RC13360L: an application for resource consent to authorise development works departures and the operation of industrial activities within part of the Te Puna Business Park prior to all pre-requisite requirements being met.

**TE PUNA INDUSTRIAL
LIMITED**

REPLY EVIDENCE OF MARK PENNINGTON

10. In this statement of evidence, I refer to various waterways in the subject area in accordance with the referencing as shown in Figure 2.1 of my report dated 14 June 2024 that was used to inform the s42A report. For clarity I have inserted this same figure in my evidence below.

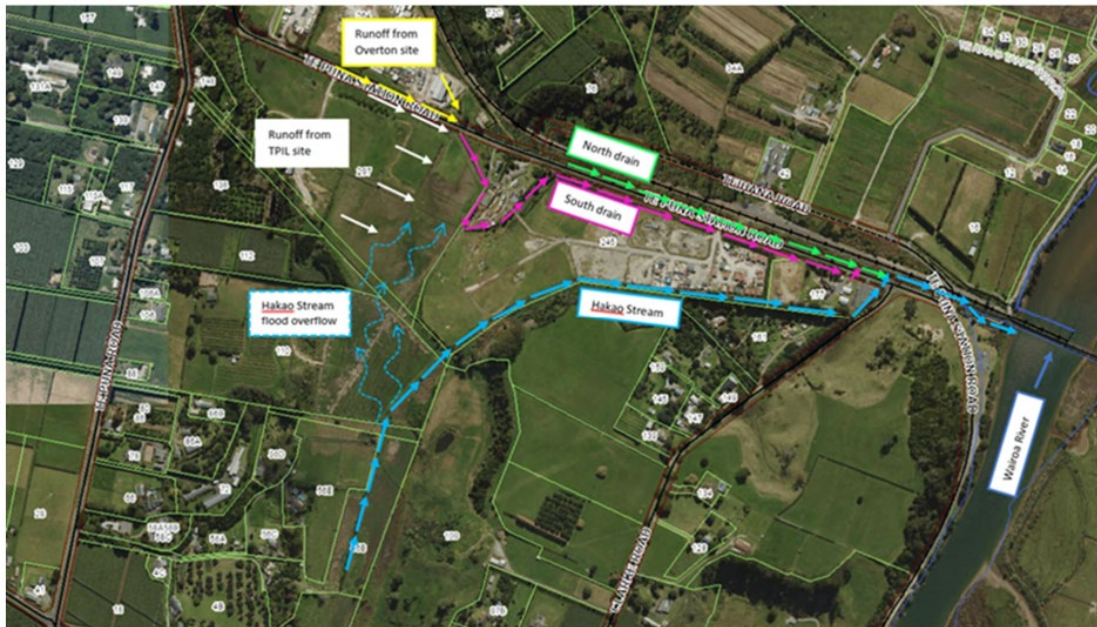
Wairoa River – refer to the figure shown in paragraph 10 of my evidence – that will convey tidal flows.
